# Access Compliance Report

## Public Rights-of-Way

Intersection ID: 53713	Main Street: N_TRYON_ST	Cross Street: PERIWINKLE_HILL_AV	Location: W
ADA ID: 26A81A590130	Ramp Type: Perp	Initial Pass/Fail: Fail	Overall Compliance: No
Severity Score: 8.75			
Codes/Mitigation Info/Possible Solution		Field Measurements/Component Compliance

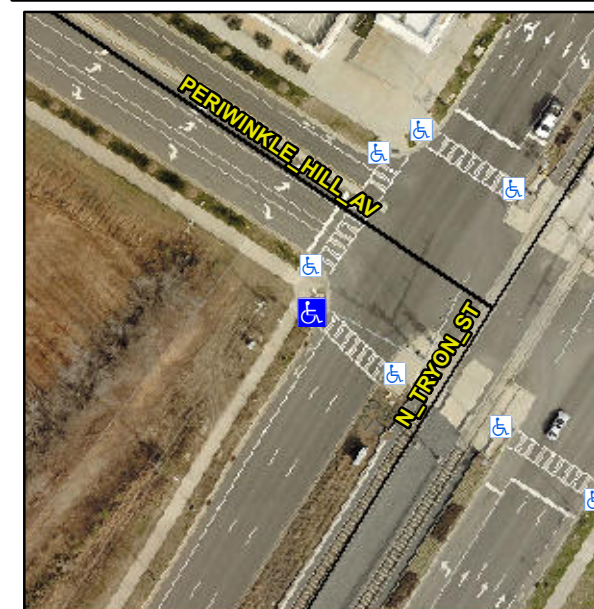
**Not Found, R304.5.1**

Compliance	Description	Data	Compliance	Description	Data
N/A	Ramp Length (in)	97.0	Yes	Ramp Slope (%)	5.0
No	Ramp Width (in)	47.5	Yes	Ramp XSlope (%)	1.5
N/A	Flare Type LT	N/A	N/A	Flare Type RT	N/A
N/A	Flare Slope LT (%)	N/A	N/A	Flare Slope RT (%)	N/A
N/A	Flare Traversable LT?	N/A	N/A	Flare Traversable RT?	N/A
N/A	Landing Length (in)	N/A	N/A	DWS Provided?	N/A
N/A	Landing Width (in)	N/A	N/A	DWS Contrast?	N/A
N/A	Landing Slope (%)	N/A	N/A	DWS Length (in)	N/A
N/A	Landing X Slope (%)	N/A	N/A	DWS Full Width?	N/A
N/A	Landing Curb? (Y/N)	N/A	N/A	DWS Offset (in)	N/A
N/A	Shared Landing?	N/A			
N/A	Gutter Ponding?	N/A	N/A	Gutter Slope (%)	N/A
N/A	Gutter Lip Ht (in)	N/A	N/A	Gutter X Slope (%)	N/A
N/A	Painted X Walk1?	Yes	N/A	Painted X Walk2?	N/A
	X Walk 1 Direction	To SE		X Walk 2 Direction	N/A
N/A	X Walk 1 Width (in)	116.0	N/A	X Walk 2 Width (in)	N/A
	X Walk 1 Slope (%)	2.5		X Walk 2 Slope (%)	N/A
	X Walk 1 X Slope (%)	0.5		X Walk 2 X Slope (%)	N/A

**Remove & Replace Entire Ramp.**
